80C186EB/80C188EB AND 80L186EB/80L188EB EMBEDDED MICROPROCESSORS SPECIFICATION UPDATE

Release Date: April, 1998
Order Number: 272897-005

Notice: The 80C186EB/80C188EB and 80L186EB/80L188EB may contain design defects or errors known as errata which may cause the product to deviate from published specifications. Current characterized errata are documented in this Specification Update.

Figure 3. INT0 And INT1 Acknowledge Failure due to Higher Priority Timer Interrupt

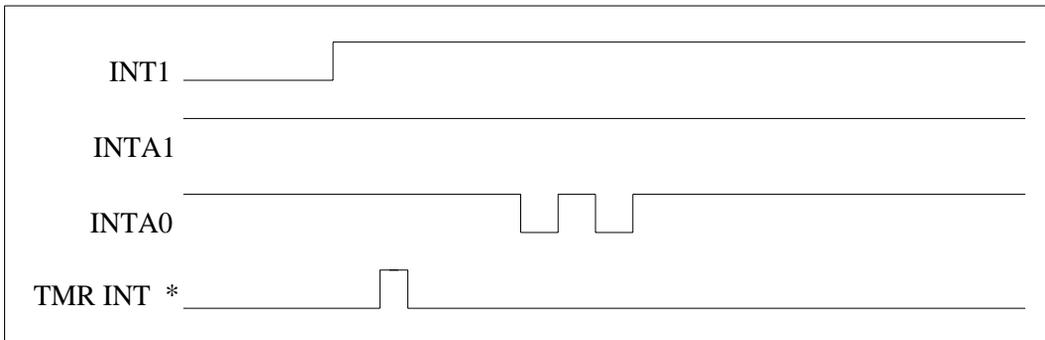
If INT0 and INT1 are configured in cascade mode and a higher priority interrupt occurs between INT1 and its expected acknowledge, then the acknowledge will appear on INTA0# instead (Figure 3).

*Note: This interrupt could be any of the following: DMA, Timers, Serial, or INT0.

| 1. Only INT1 is configured in cascade mode and is lower priority than at least one other interrupt. | Use only INT0 in cascade mode instead, or make INT1 the highest priority interrupt, or use hardware workaround. |
| 2. INT1 and INT0 are both in cascade mode. | Use only one interrupt in cascade mode, or use hardware workaround. |
| 3. Only INT0 is configured in cascade mode and is lower priority than INT1. | Make INT0 higher priority than INT1, or use hardware workaround. |

Figure 4. Correct INT0 Acknowledge Operation with a Simultaneous INT1

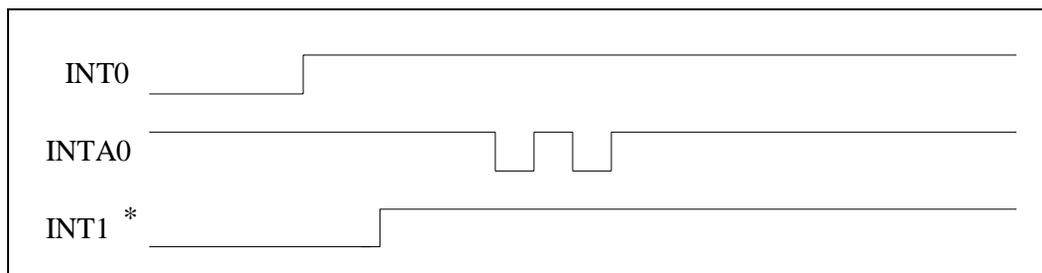
Correct operation acknowledges INT0 on INTA0#. Normally, this occurs even if there is a higher priority INT1 after INT0 but before the acknowledge (Figure 4).

*Note: INT1 is the only interrupt that causes the errata to occur.

Figure 5. Incorrect INT0 Acknowledge Operation with a Simultaneous INT1

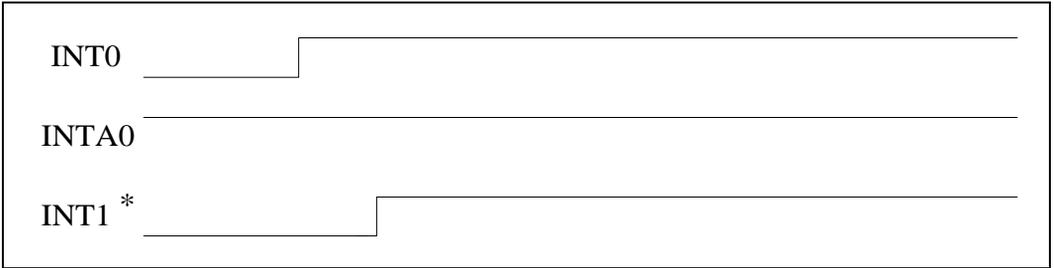
The errata occurs when INT1, which is higher priority than INT0, occurs between INT0 and its expected acknowledge. The processor completes internal interrupt acknowledge cycles as seen on the status lines but no acknowledge cycle is sent on the INTA0# output (Figure 5).

*Note: This problem occurs only if INT1 is higher priority than INT0.

Figure 6. INT0 and INT1 Acknowledge Failure Due to the Higher Priority INT1

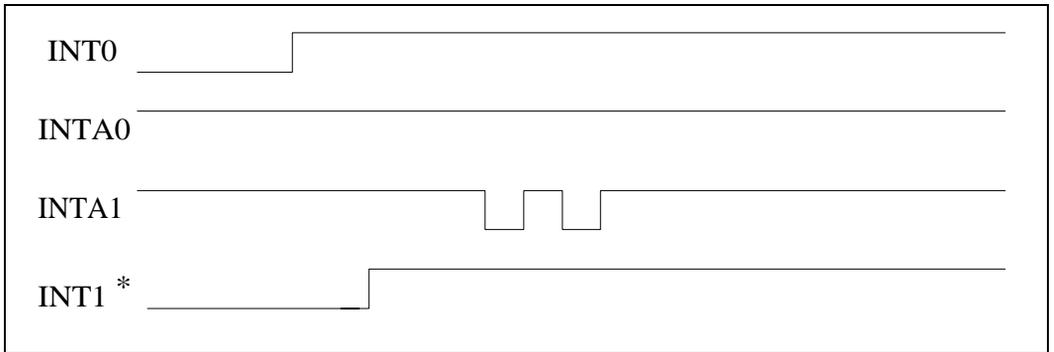
If INT0 and INT1 are configured in cascade mode and the higher priority INT1 occurs between INT0 and its expected acknowledge, then the acknowledge will appear on INTA1# instead of INTA0# (Figure 6).

*Note: This problem occurs only if INT1 is higher priority than INT0.

1. Pull data bus lines 0 to 7 to a known value (using pull-up resistors) to force a defined value on the bus when the errata occurs.

2. Program cascaded interrupt inputs on the 186 to be level sensitive; otherwise, the 186 does not recognize that the interrupt is still active.
3. Write a simple service routine for the interrupt type defined in step 1.

Figure 7. NMI Ignored During HLT Entering Powerdown

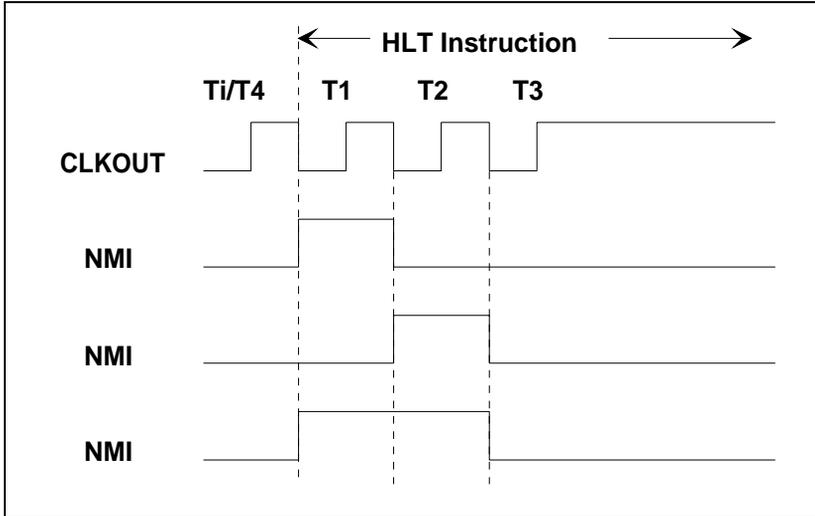
The problem occurs when an NMI occurs during execution of the HLT instruction. NMI is only serviced at valid instruction boundaries. The HLT instruction, when entering Powerdown, does not really have a boundary, it extends until Powerdown is exited. If NMI occurs between the beginning the T1 bus state and the end of the T2 state, but does not extend into T3, it will not be recognized, and the processor will enter Powerdown mode. The processor does not recognize the NMI request during the HLT instruction until the internal clock has stopped (at the end of T2).

The figures below show NMI occurring at different times during execution of the HLT instruction. Two cases are shown. **Figure 7** shows cases where NMI is not recognized. **Figure 8** shows cases where NMI is recognized. Both cases assume setup and hold time requirements are met for the NMI input.

In a typical system design using Powerdown mode, NMI can only occur after Powerdown is entered and the clock is stopped. The simplest solution to the problem is to not assert NMI unless the processor has entered Powerdown Mode.

If the system requires periodic NMI pulses, then the NMI pulse width must be long enough to ensure that it will extend into the T3 state of the HLT instruction. A NMI pulse width of three CLKOUT periods guarantees this.

Figure 8. NMI recognized during HLT entering Powerdown

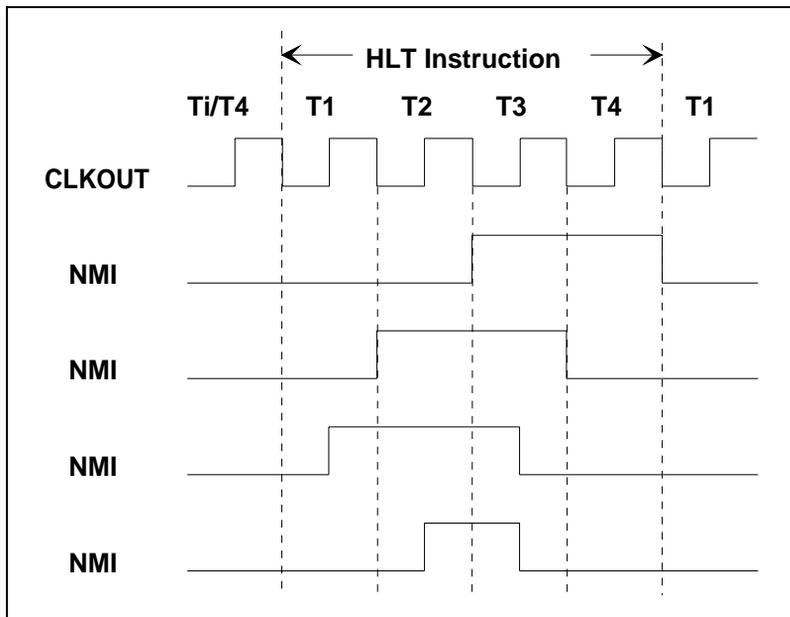
For the NMI to be recognized during the execution of the HLT instruction, the pulse must extend into T3. At this point, the processor has entered Powerdown and synchronized the NMI pulse. The NMI will be processed, but the processor will never enter Powerdown. Essentially, because NMI is active, the processor exits Powerdown as soon as it enters.
